# UNITED STATES PATENT AND TRADEMARK OFFICE

10/571,880

<b>Office Action Summary</b>	<b>Application No.</b> 10/571,880	<b>Applicant(s)</b> WEHLER, HERBERT	
	<b>Examiner</b> Gregory J. Strimbu	<b>Art Unit</b> 3634

FIG. 3

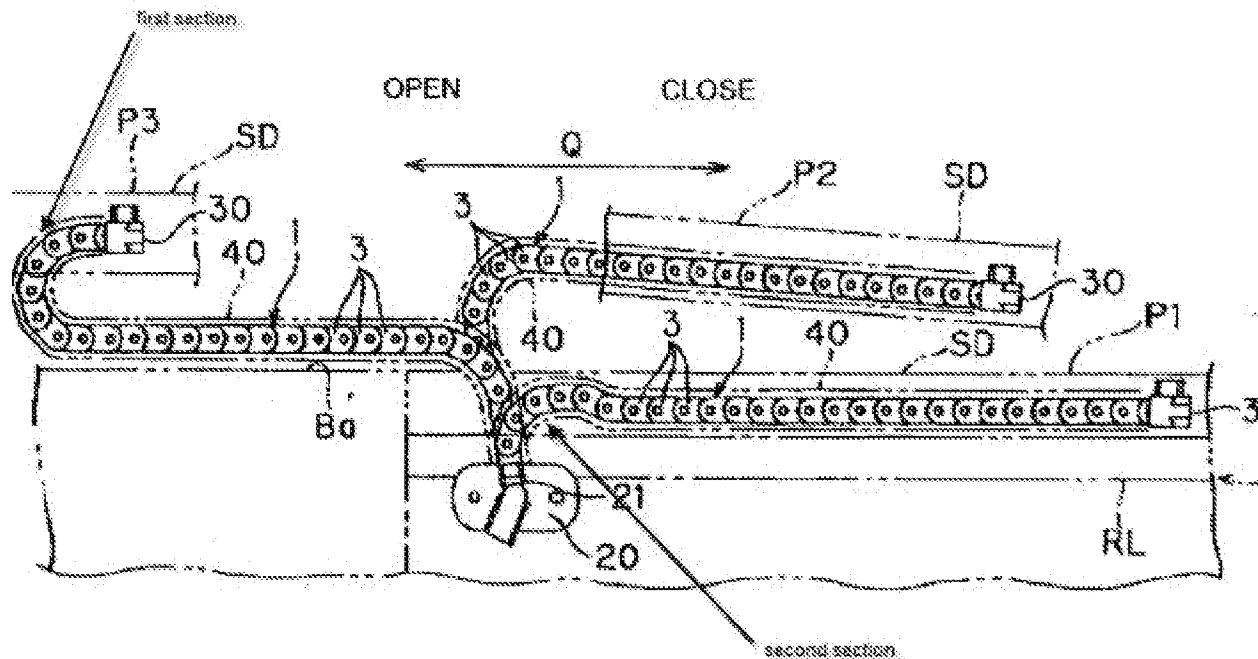
Claim 22 is rejected under 35 U.S.C. 102(e) as being anticipated by Kobayashi et al. (US 2004/0003543). Kobayashi et al. discloses an energy guide chain system for a vehicle, the vehicle having a chassis B and a sliding door SD that can be moved between a closed position and an open position on the chassis, and the energy guide chain system comprises:

a carrier 30 connected to the sliding door; and

an energy guide chain 1 having:

a first end connected to the carrier 30 and a second end connected to the chassis at 21; and

a region (not numbered, but shown in figure 3) between the first end and the second end, and the region has a first section (labeled below) that defines a first radius of curvature when the sliding door is in the open position, and a second section (labeled below) that defines a second radius of curvature when the sliding door is in the closed position.
